INSPECTION REPORT
Sedimentation Structure
N10-C
Kayenta Mine
Navajo County, Arizona

for
PEABODY COAL COMPANY

Dames & Moore
10139-011-22

Plate 1

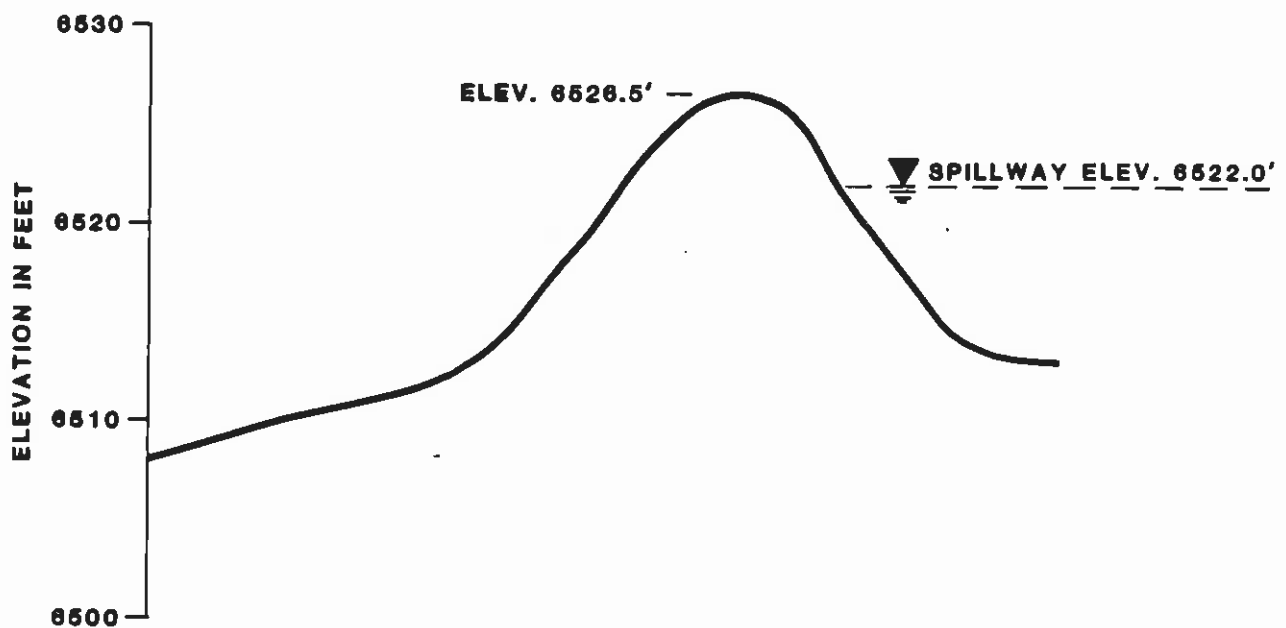
The storage capacity and spillway capacity of Structure N10-C are adequate; however, the spillway does not have an outflow channel or adequate erosion protection. A trapezoidal outflow channel should be constructed along the alignment B-B' shown in Plate 1. The channel profile is shown in Plate 4 and the required dimensions are shown in Plate 5. Both the spillway and outflow channel should be protected against erosion using geotextile and gravel as shown in Plate 5.

Plate 2

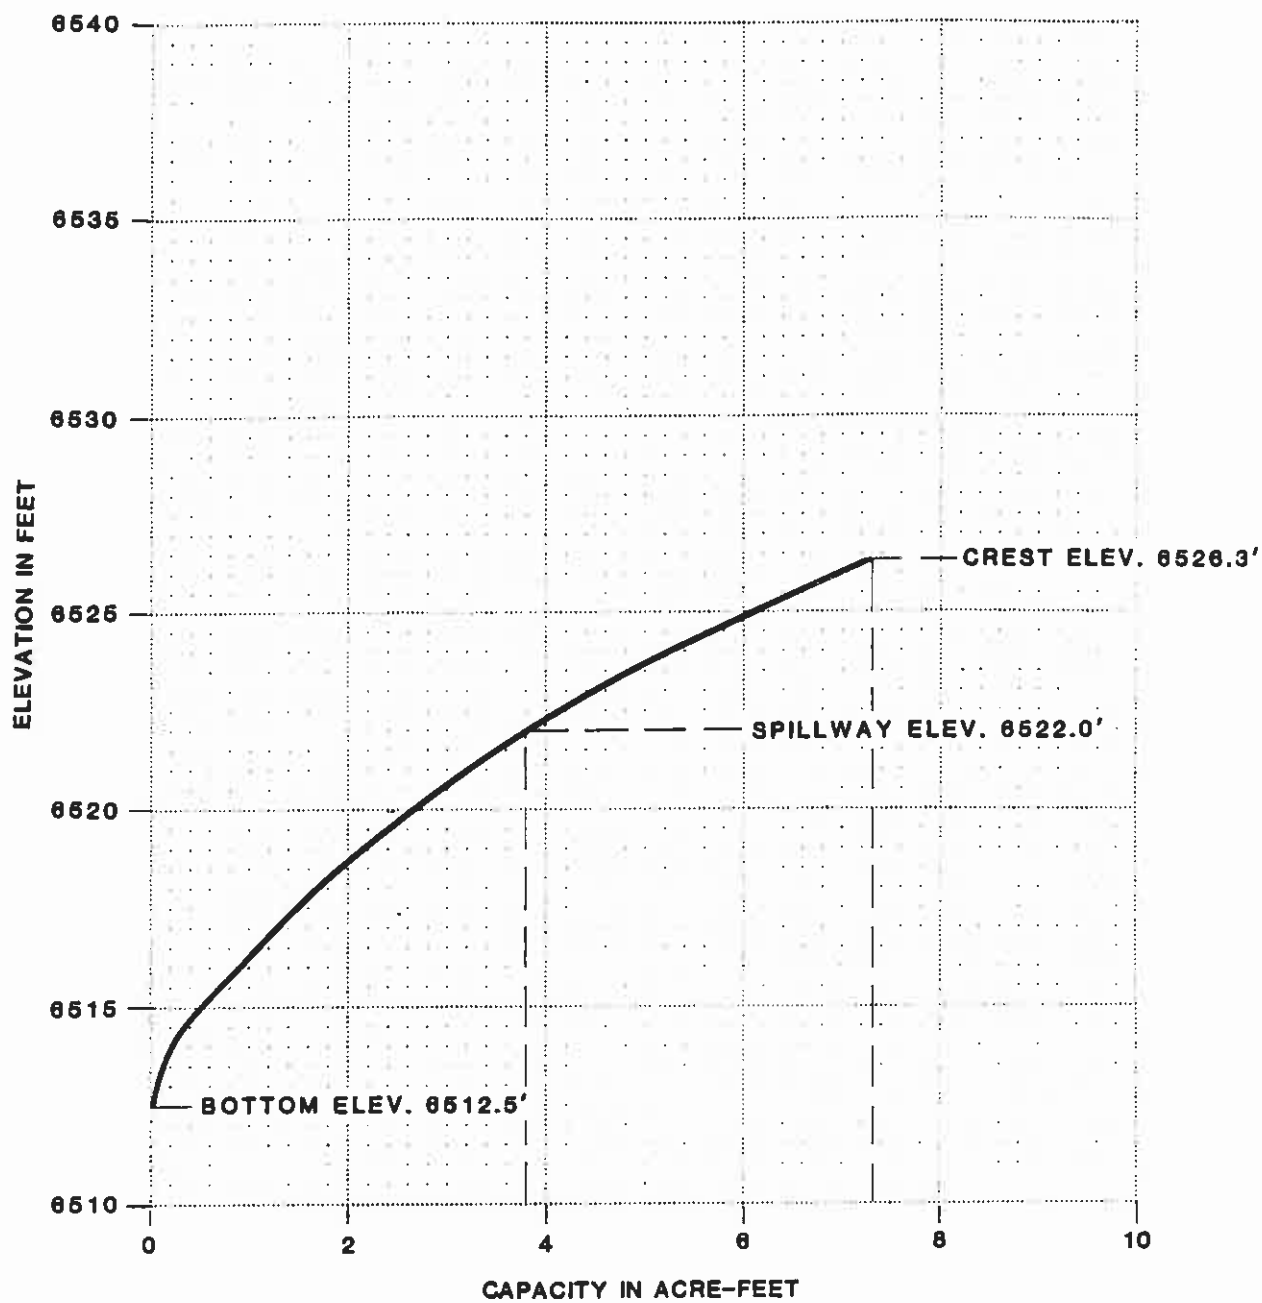
The N10-C embankment is lower in height; however, the downstream slope is steeper than the category standard; therefore, the embankment has factors of safety less than the design minimum.

The inspection of Structure N10-C indicated that the only geotechnical problem is rill erosion on the upstream and downstream slopes and the side slopes of the spillway channel. Correction of erosion is considered a periodic maintenance task and does not require remedial action. The downstream slope should be flattened to 3.25 horizontal to 1 vertical to meet stability requirements.
